AC Voltage Sensing inputs DTSC-200A /easYgen-100/1000 controls

Justin Schneider - 2026-07-27 - [easYgen-1800](#)

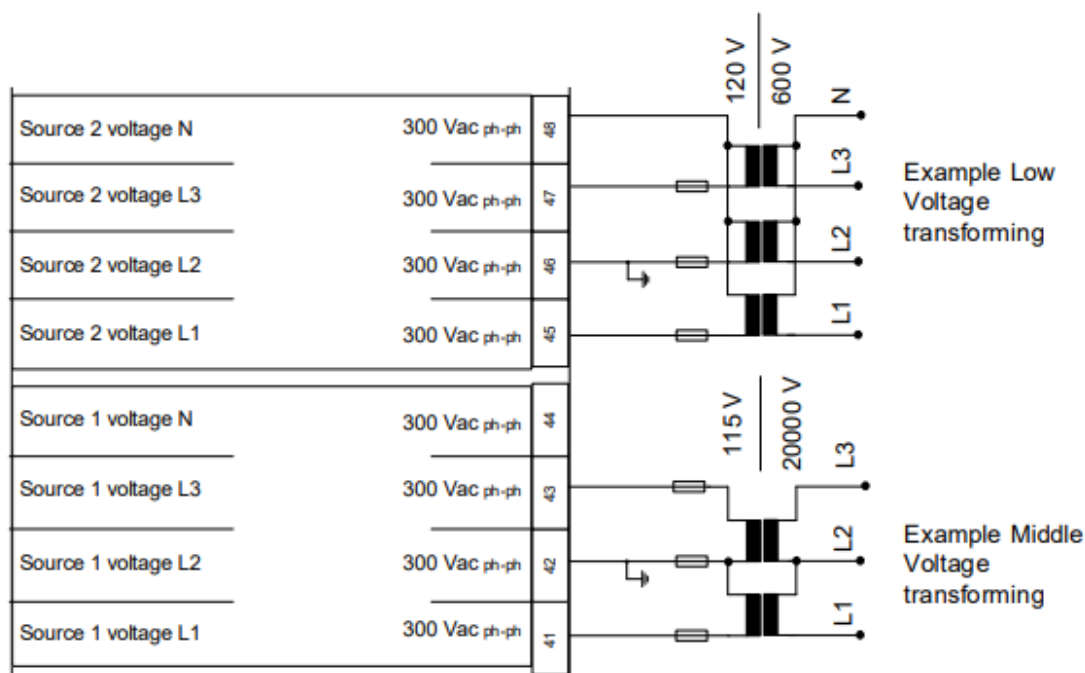
People installing DTSC-200A , easYgen-400, -600, -800, - 1400, -1600 , - 1700 & -1800 controls in an 400, 440, 480 VAC voltage application are sometimes confused , if they are seeing this pic in instruction manual :

To be compliant to UL6200 standard, we have to limit Line to Line voltages to **maximum 300VAC**.

Used voltage sensing connectors have UL up to 300V Line to Line (E-60425-19931013).

If you built a control panel which is not according to UL6200 you can go up to 480VAC Line to Line as described in manuals.

Measuring values, voltages		~ / Δ
- Measuring voltages		
Rated value (V_{rated})		277/480 Vac
Maximum value (V_{max})		max. 358/620 Vac
Maximum value (V_{max}) according to UL6200		
		max. 173/300 Vac
